**Quirksinger
 Laneway House**

ISSUED FOR	DATE
REZONING APPLICATION	2025-02-12
REV #	DESCRIPTION

CNV Staff Comment	Design change requested?	Design change required?	Smallworks Response	CNV Response
1 Land Use				
1.1 The maximum density according to the Residential Level One land use designation of the Official Community Plan and RS-1 Zoning is 0.5 FSR. The development including the Heritage house is 0.32 FSR which complies with the maximum permitted density.	No	No	N/A

Pre-Consultation Memo Response + Floor Plans

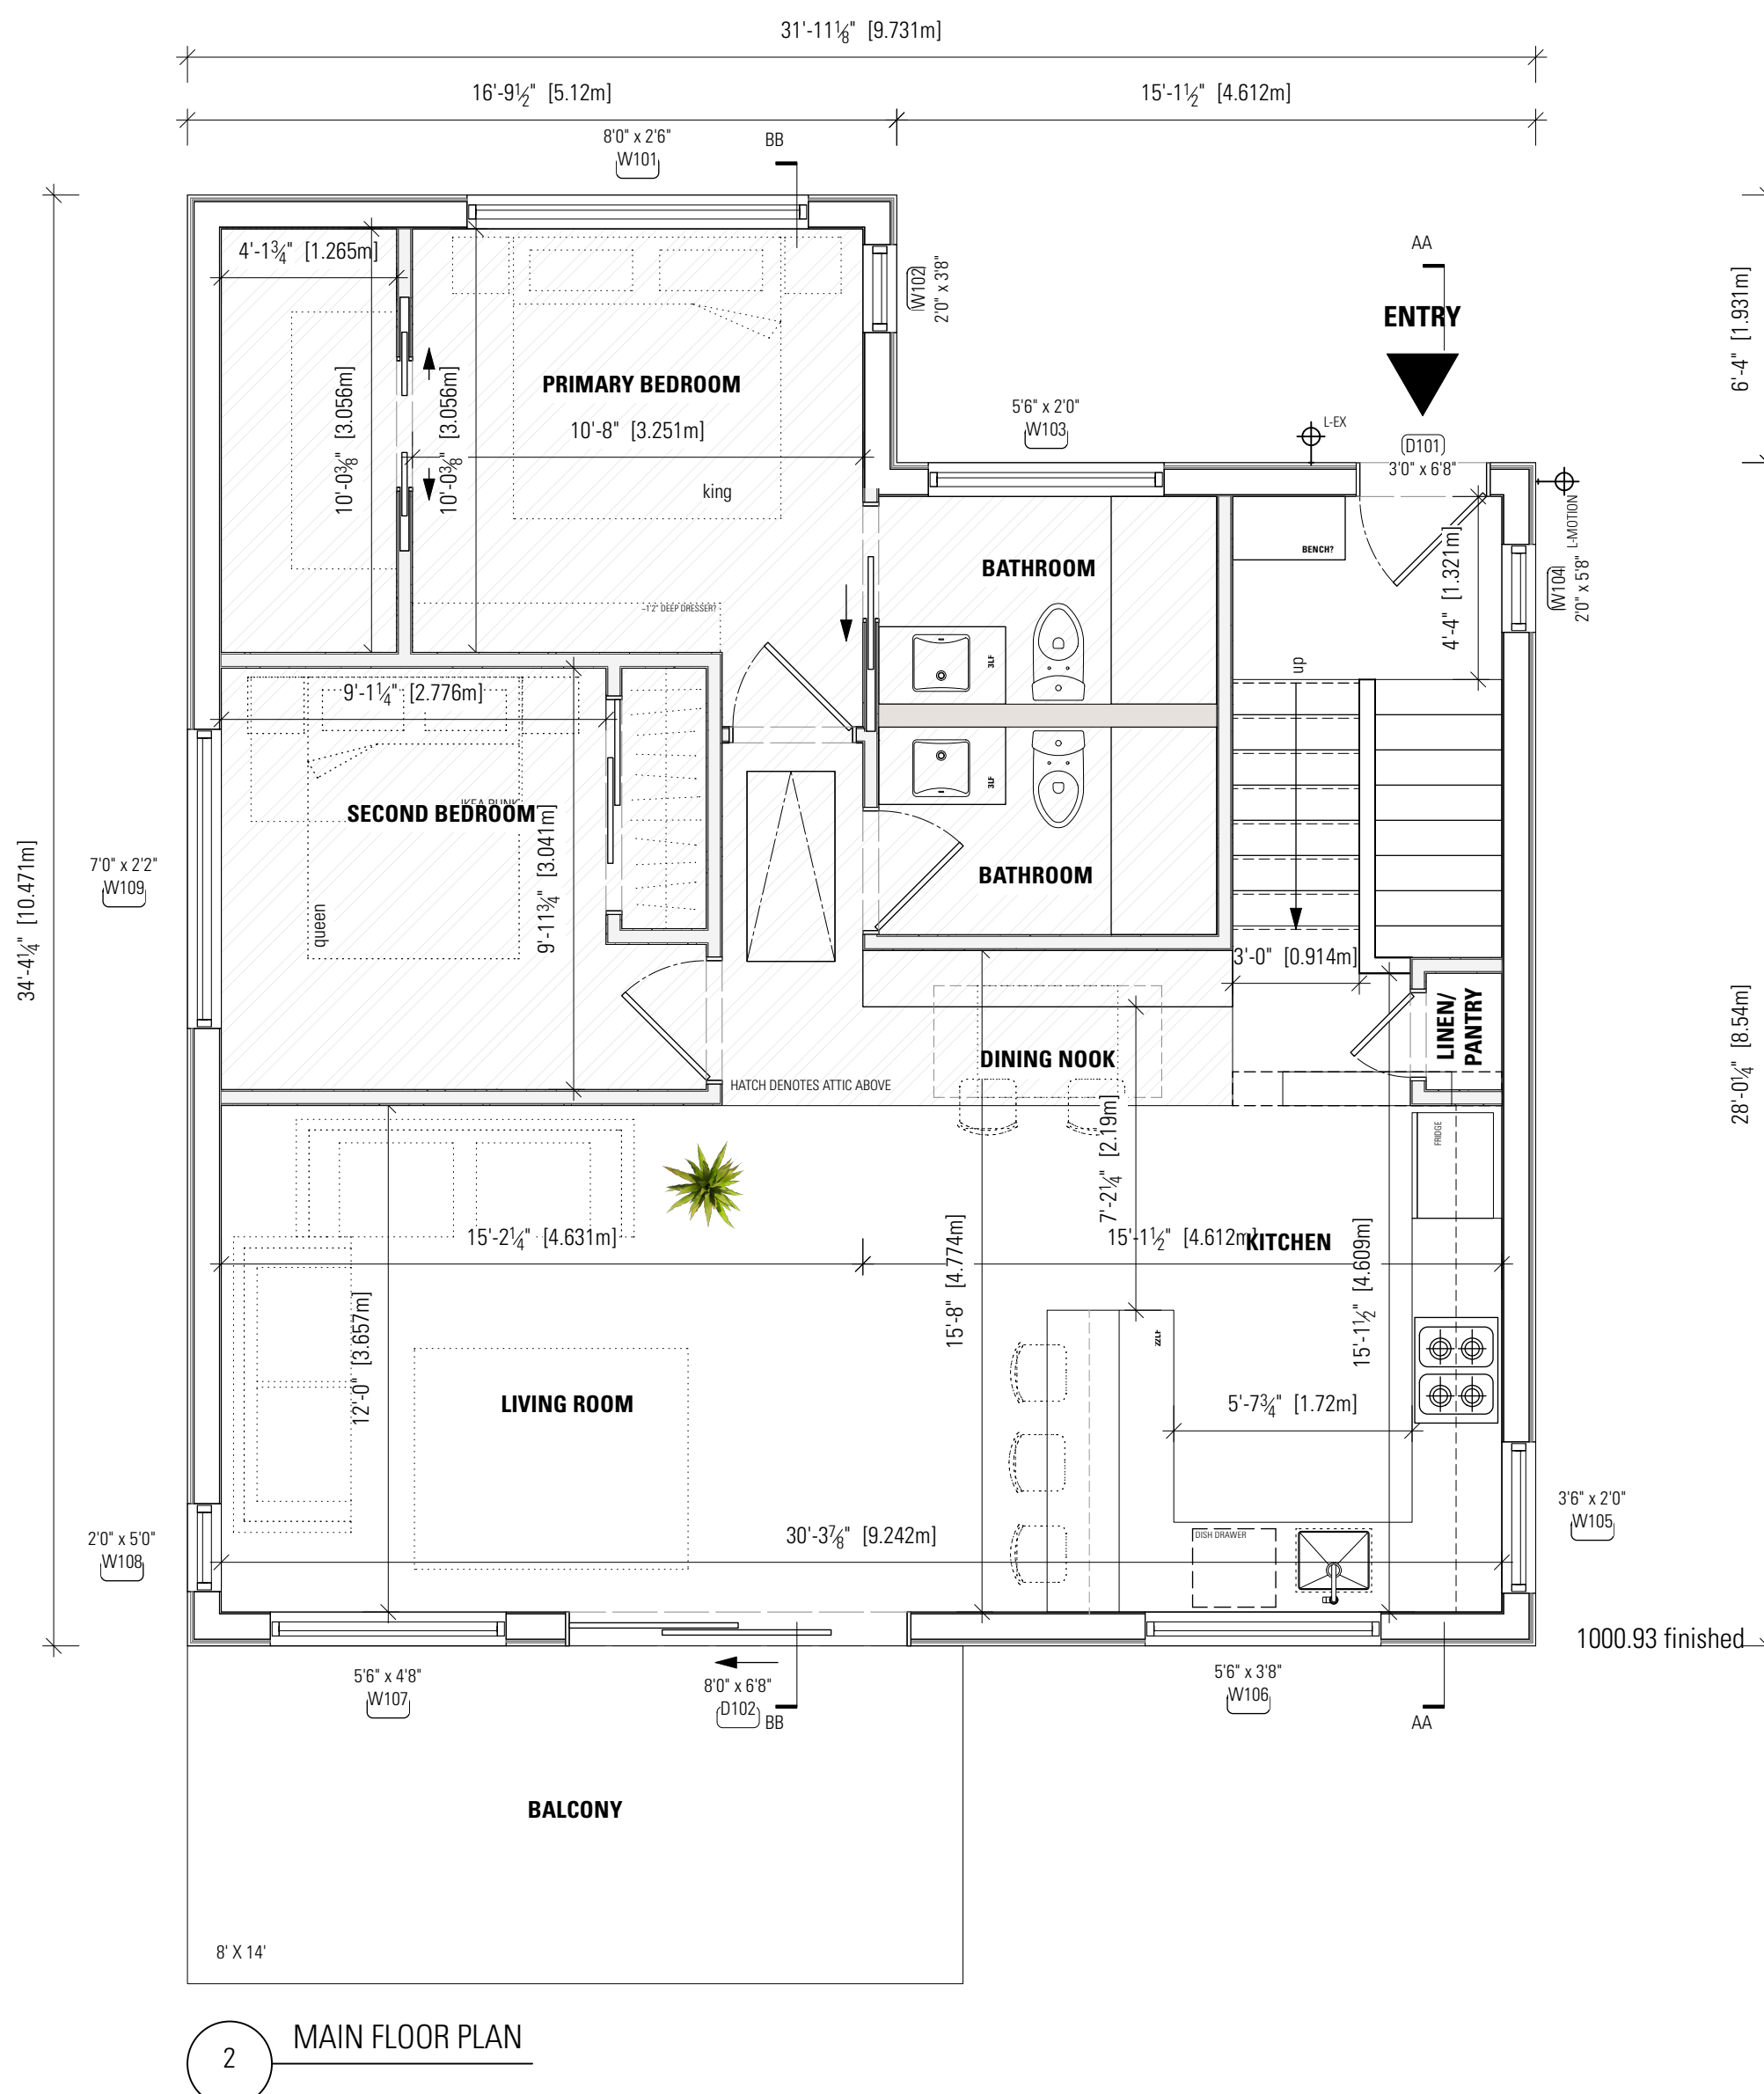
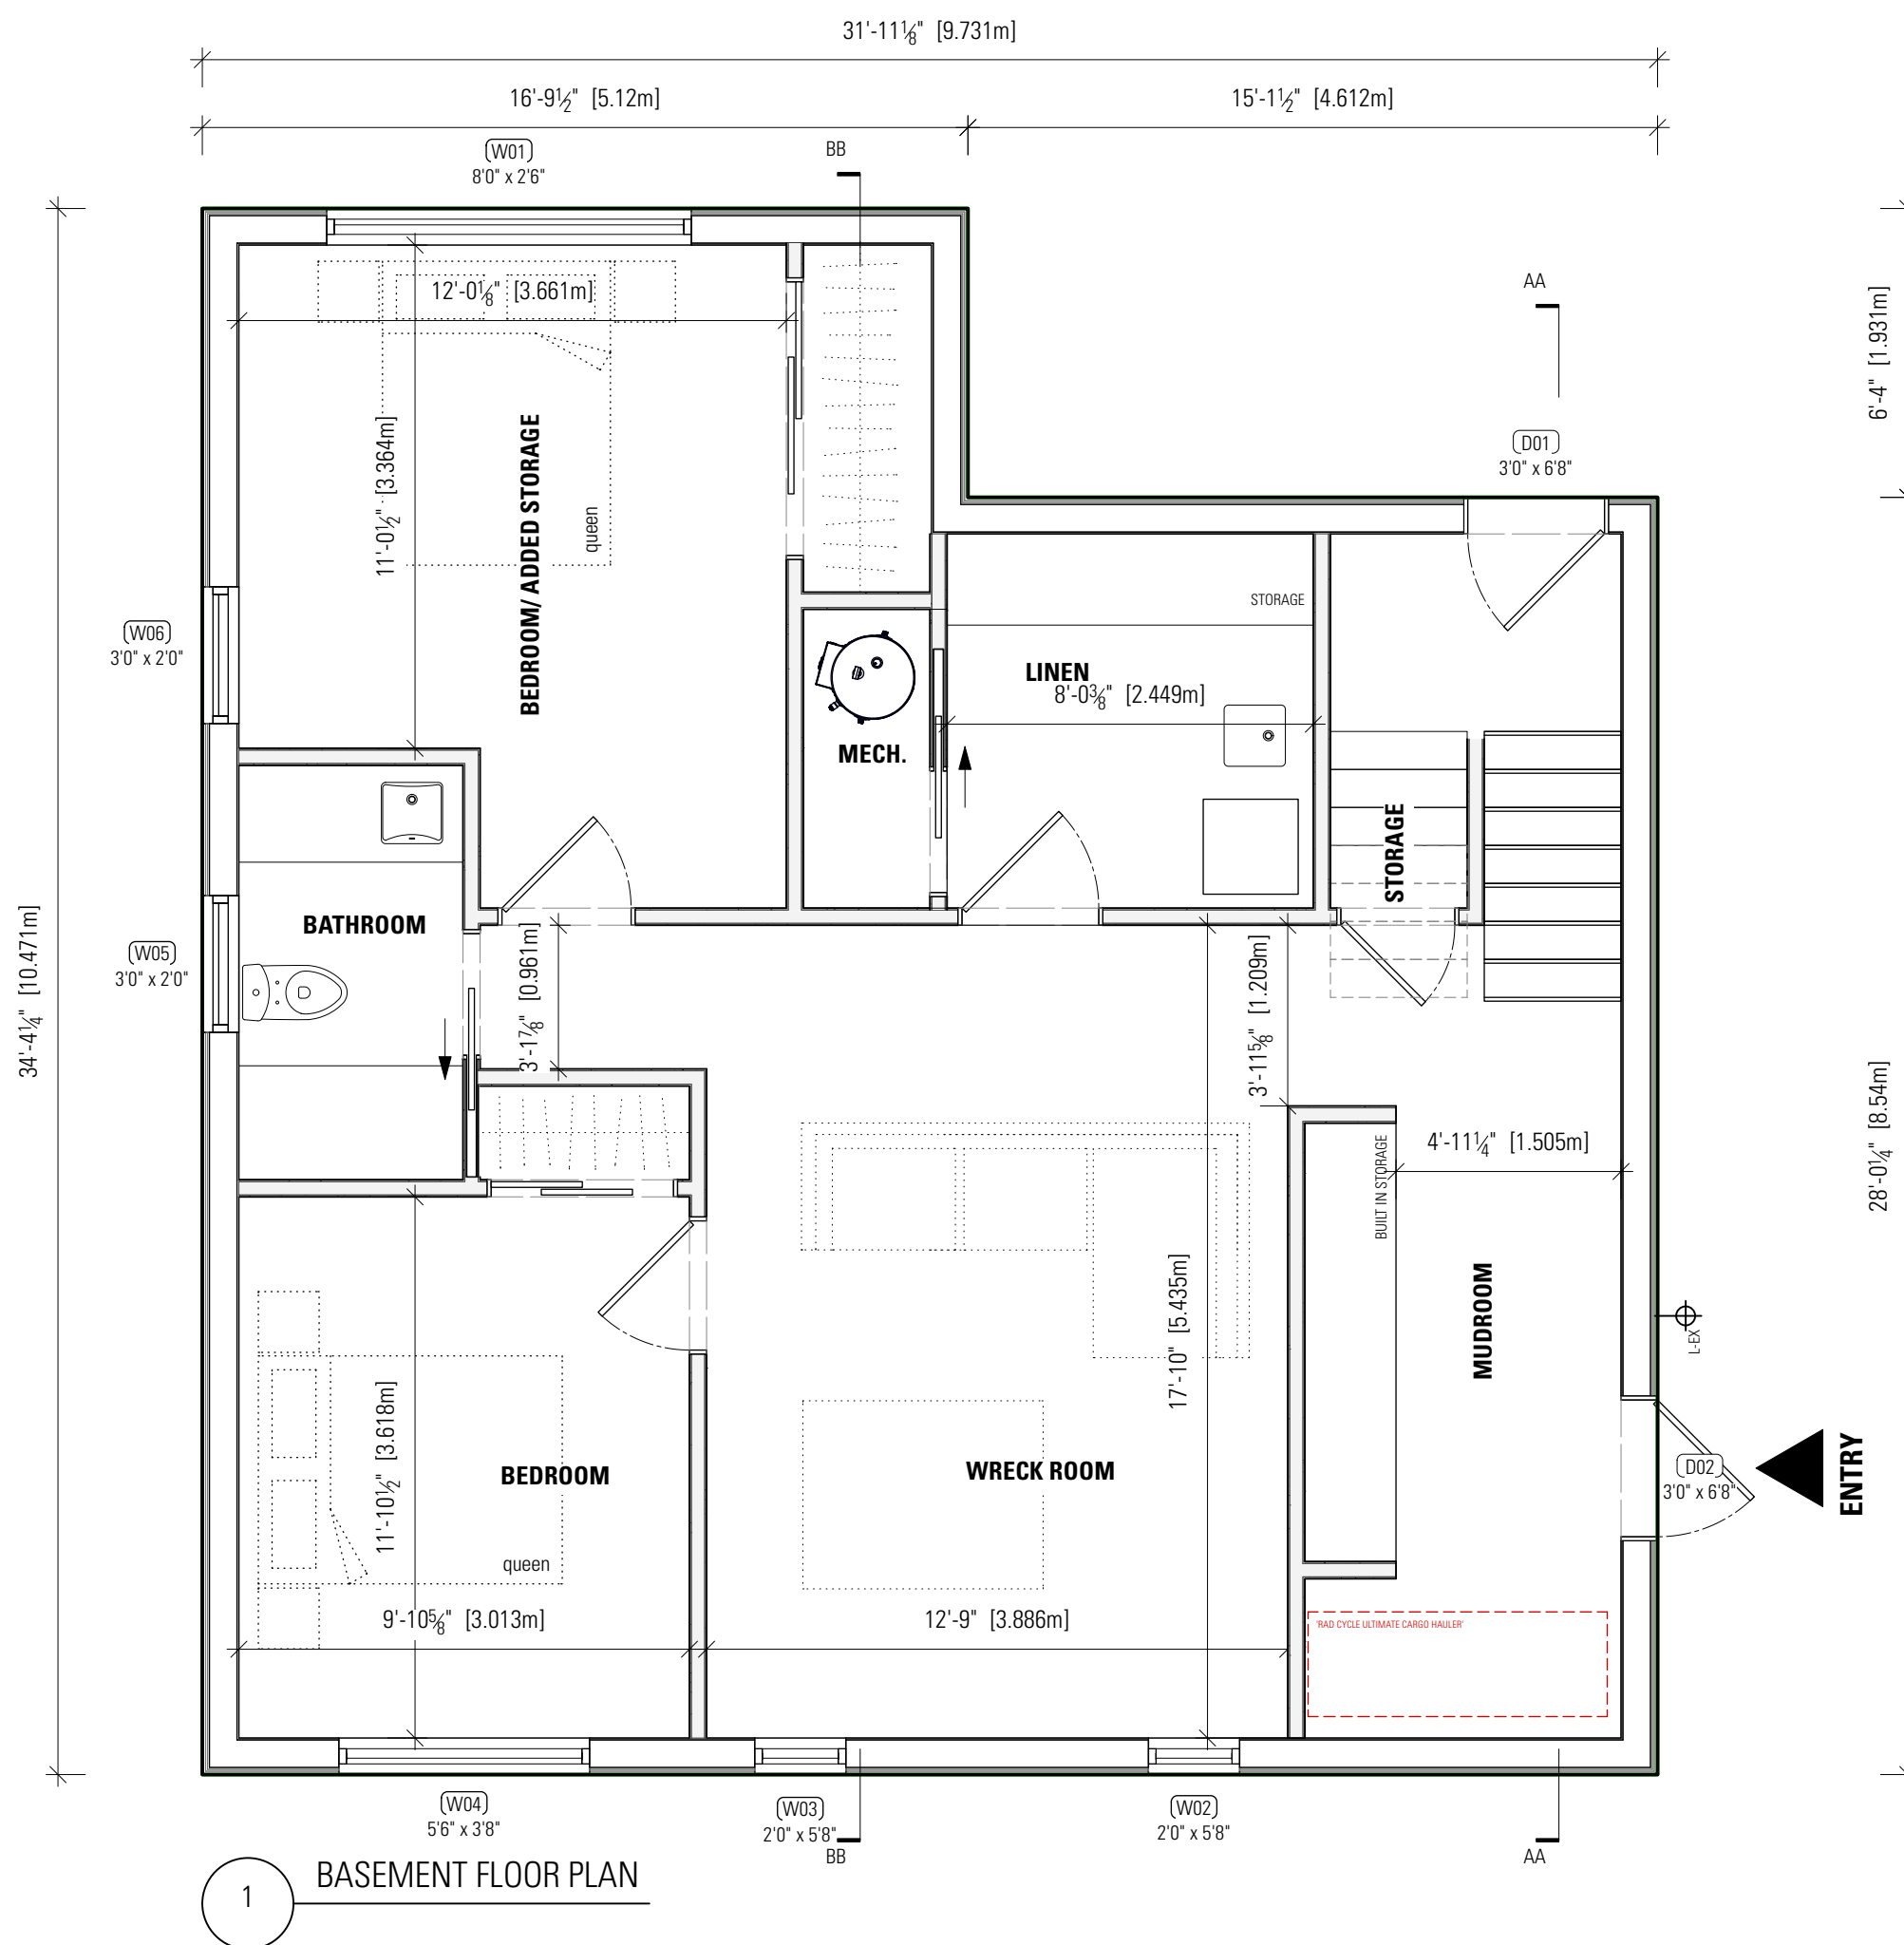
3.1 As per the Accessory Coach House Development Permit Guidelines, Section 3.1.3, the emergency pathway shall not be obstructed or overlap with any parking spaces, garbage storage areas, or other paved areas that may be occupied by movable items. The proposed design of the parking space on the east side of the coach house has interrupted the pathway connection to the main entrance and is therefore unacceptable. If it's not feasible to propose two parking stalls while following the mentioned regulations, the City may explore additional incentives for minor variances in parking design standards.	Yes	No	We consulted with Kyle Pickett from the CNV Planning and Development team regarding another project of ours, and were advised that the emergency pathway can lead to "any main entrance, whether that is facing the yard or facing the lane, either can work". <i>"I spoke with the fire department, and they confirmed that the basement entrance is acceptable for emergency access. Please ensure that both entrances have clearly visible unit numbers from the street and lane, and that these numbers are illuminated at night. I will save this email in your application file."</i> This is in line with our understanding, and we have taken this approach on several of our other coach house projects in the CNV, in which the approved emergency pathway leads to rear and side entrances. As such, given that the proposed emergency pathway in this case (E 5th Street) is uninterrupted (not obstructed or overlapping with any parking spaces, garbage storage areas, or other paved areas that may be occupied by movable items) to the lower main entrance, we believe that it complies with the CNV requirements and should not need revision.	Parinaz Askarian, Planning Assistant on 18 June, 2024--

3.3 As per the Accessory Coach House Development Permit Guidelines, Section 4.3.1, balconies and decks located on the second floor should face the rear lot line or exterior side lot line, and any portion of the balcony or deck facing interior lot lines should provide a privacy screen that is minimum of 1.5 m (5 ft.) high. While the homeowners have expressed a desire to maximize the view to the south and increase light exposure in the adjacent living area, it's crucial to note that the current massing and slope of the site allow for direct sightlines from the deck into the primary property. Given the intention for this development to undergo stratification, it's necessary to follow the guidelines and install a privacy screen to address privacy issues and meet the regulations.	Yes	Yes	A privacy screen to the rear deck has been proposed	
4 Urban Design
